**City of Portland, Maine – Building or Use Permit Application** 389 Congress Street, 04101, Tel: (207) 874-8703, FAX: 874-8716

Location of Construction: <b>18 City Point Rd Peaks Island</b>		Owner: <b>T. Covington Johnson</b>	Phone: <b>766-3375</b>	Permit No: <b>990091</b>
Owner Address: <b>P.O. Box 48 Peaks Isl, ME 04108</b>		Lessee/Buyer's Name:	Phone:	BusinessName:
Contractor Name: <b>SAA/Owner</b>		Address:		Phone:
Past Use: <b>1-fam</b>	Proposed Use: <b>Same</b>	<b>COST OF WORK:</b> \$ <b>20,000.00</b>	<b>PERMIT FEE:</b> \$ <b>120.00</b>	<b>PERMIT ISSUED</b> <b>FEB 8 1999</b> <b>CITY OF PORTLAND</b> 087-3-009
		<b>FIRE DEPT.</b> <input type="checkbox"/> Approved <input type="checkbox"/> Denied	<b>INSPECTION:</b> Use Group: Type:	
		Signature:	Signature:	
Proposed Project Description: <b>Change Pitch of Roof from 4/12 to 12/12 as per plans</b>		<b>PEDESTRIAN ACTIVITIES DISTRICT (P.A.D.)</b>		Zoning Approval:
		Action:	Approved <input type="checkbox"/> Approved with Conditions: <input type="checkbox"/> Denied <input type="checkbox"/>	<b>Special Zone or Reviews:</b> <input type="checkbox"/> Shoreland <input type="checkbox"/> Wetland <input type="checkbox"/> Flood Zone <input ty

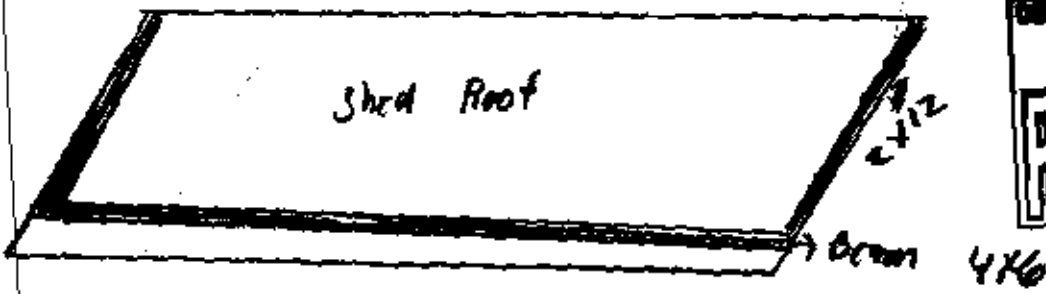
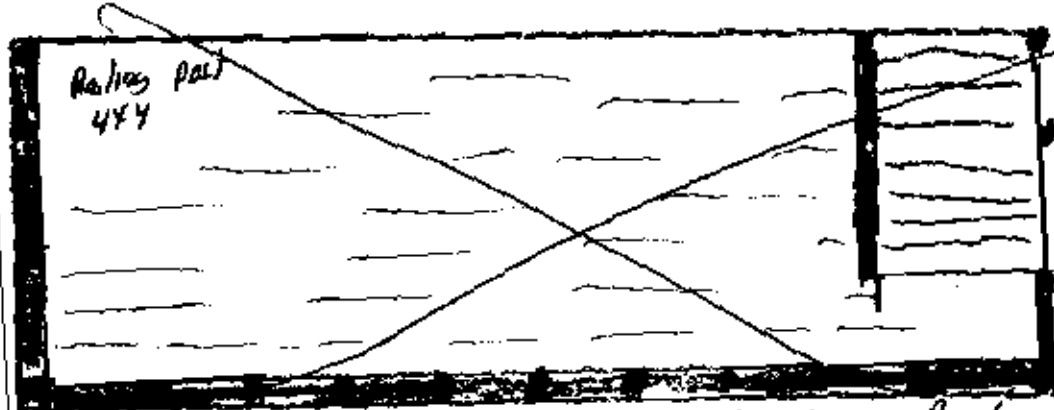
Removed  
per Corey  
Johnson  
2/5/99

Shed Roof  
~~Deck on top~~  
NO Deck on top  
per Corey Johnson

Deck on top of shed Roof

No Deck  
per Corey  
Johnson  
2/5/99

Plot Plan

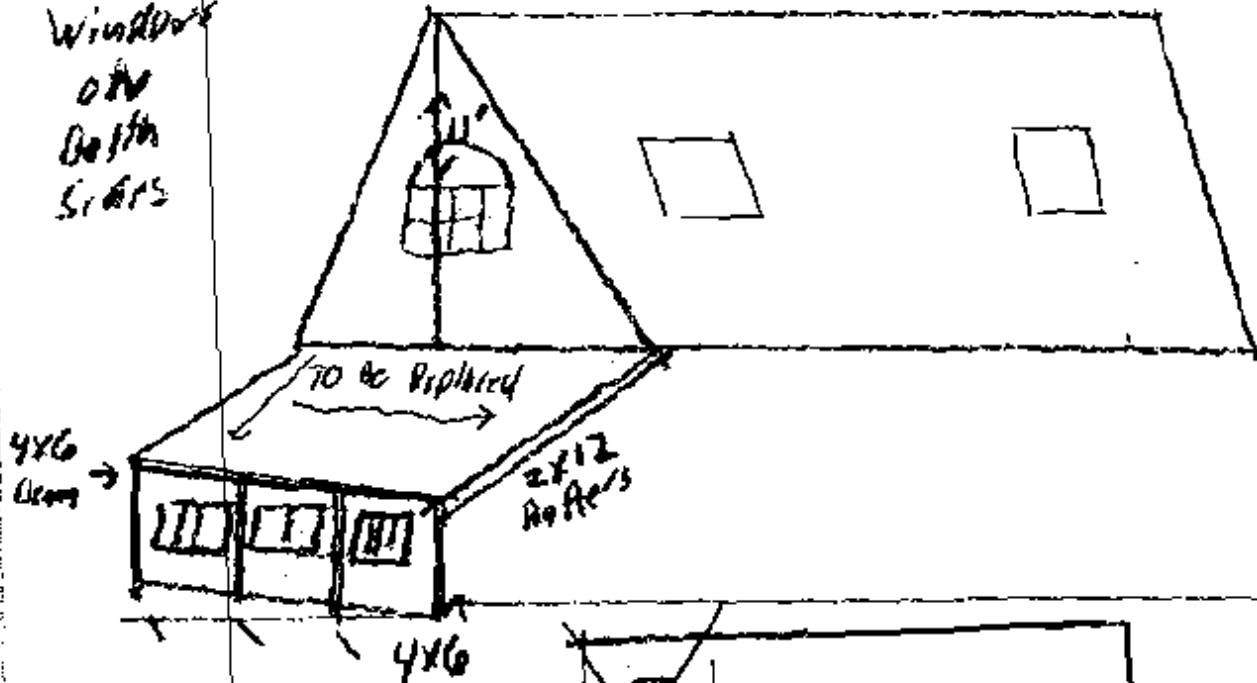
to be removed

Road View  
New construction  
Roadside view

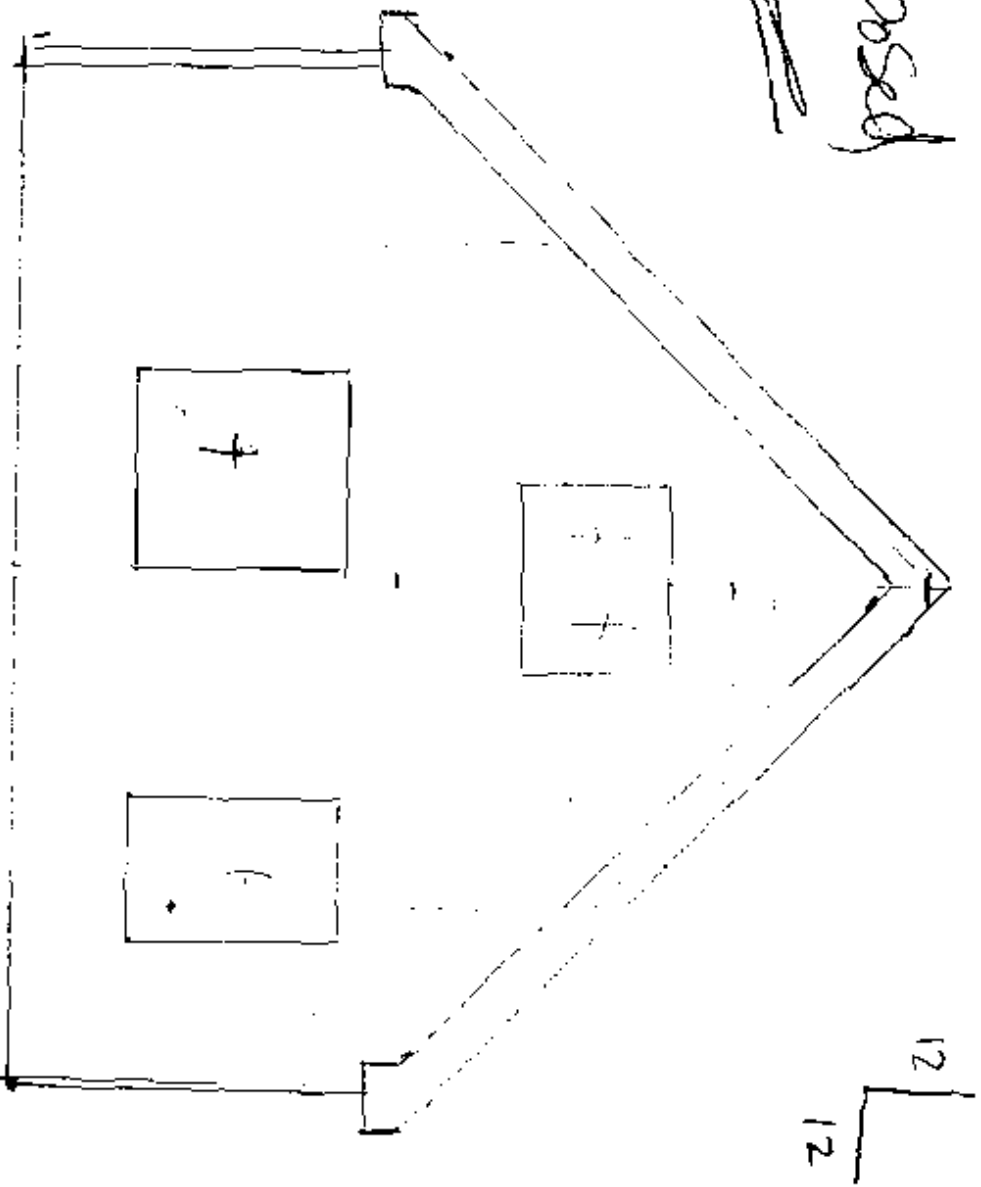
This was what was  
approved for Court Johnson.  
This is what he should  
be constructed. No  
occupancy is to be granted  
unless this is the  
work that has been  
built on site

OCEAN VIEW  
New Construction

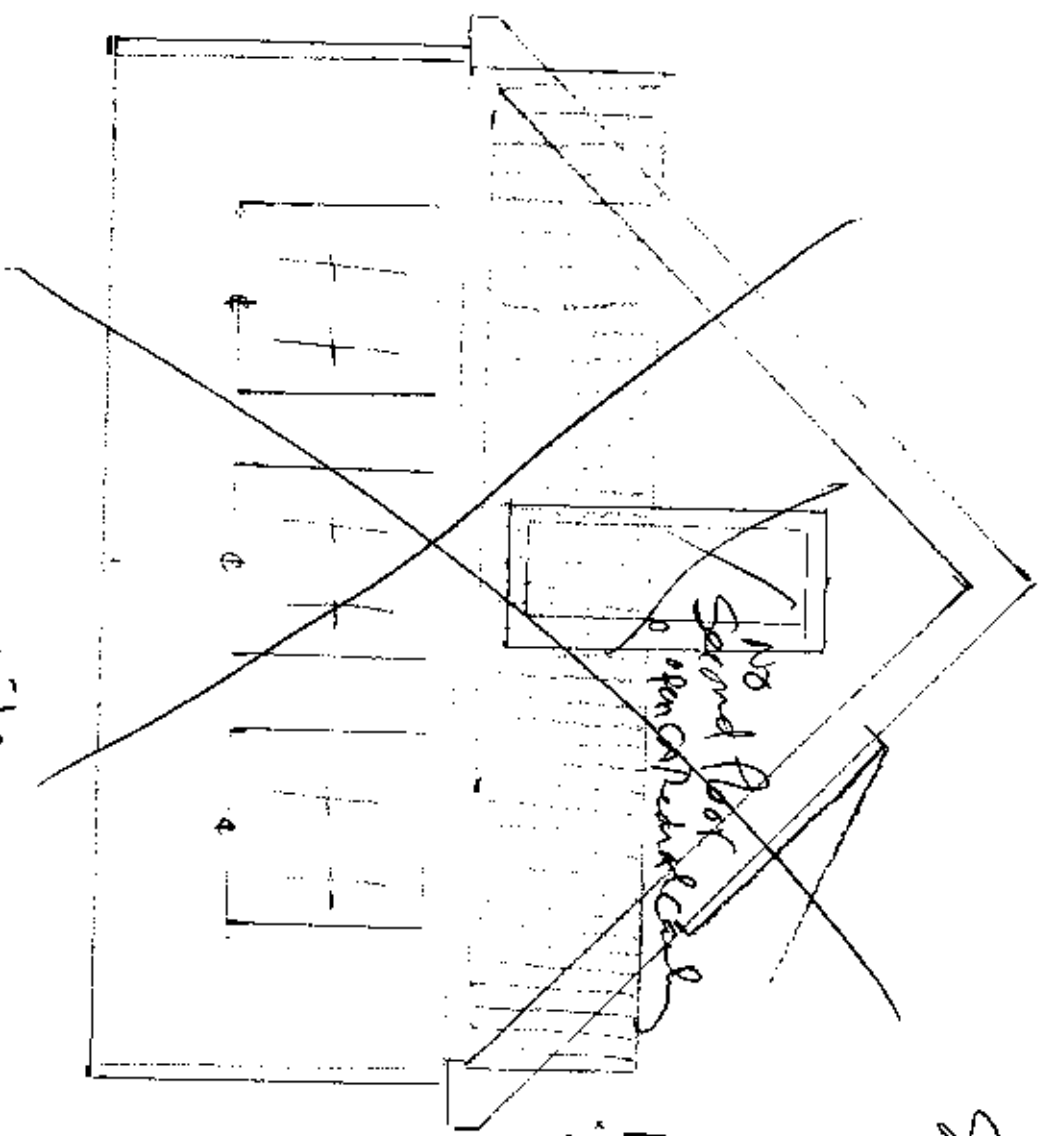
See revised  
plans

No Deck -  
just old shed  
roof

No  
Second floor  
open staircase

South side views new construction

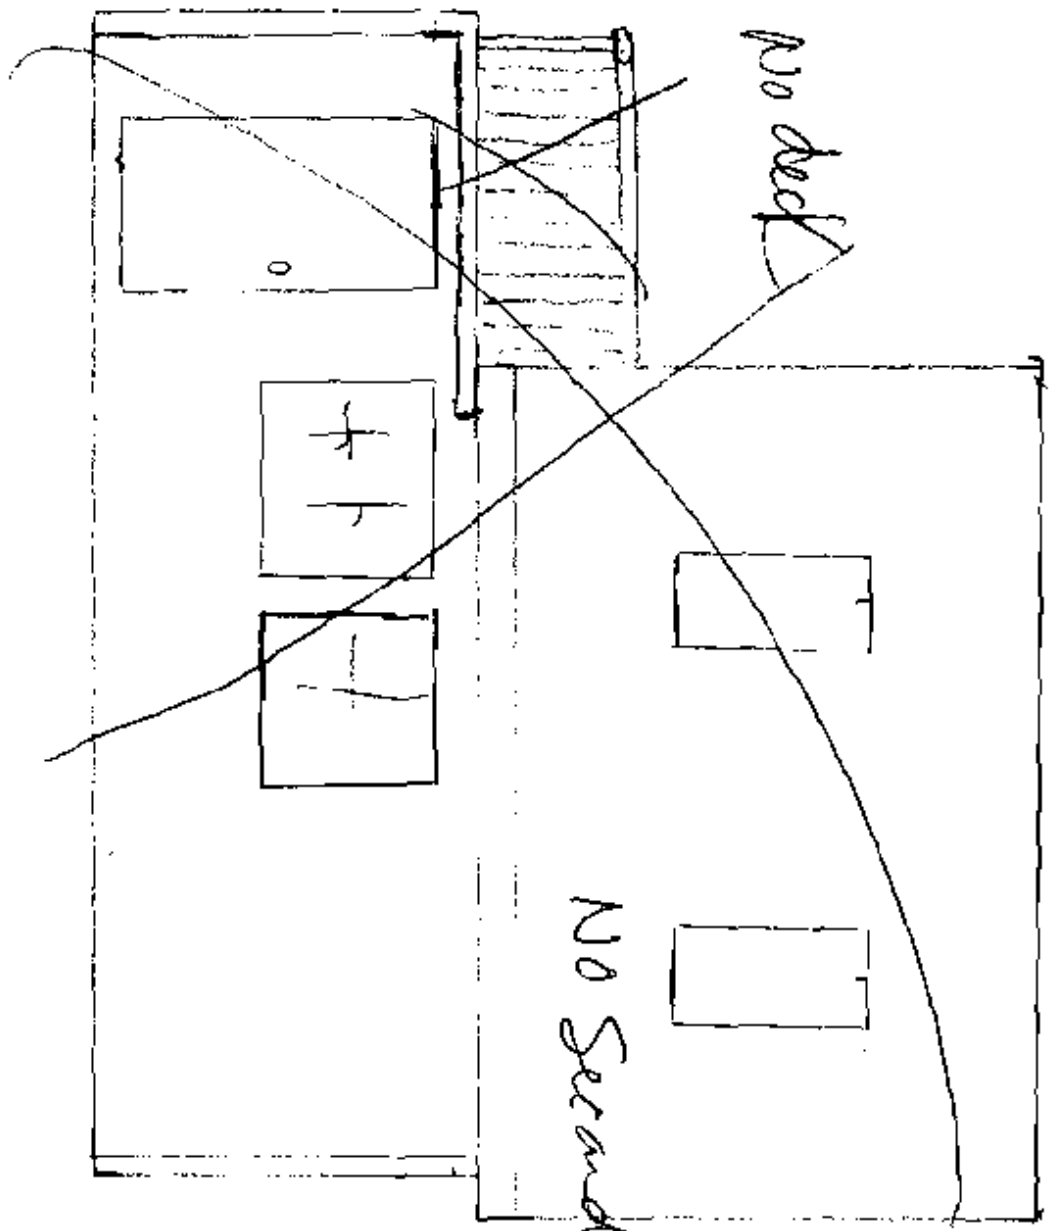
No deck

No Second Floor
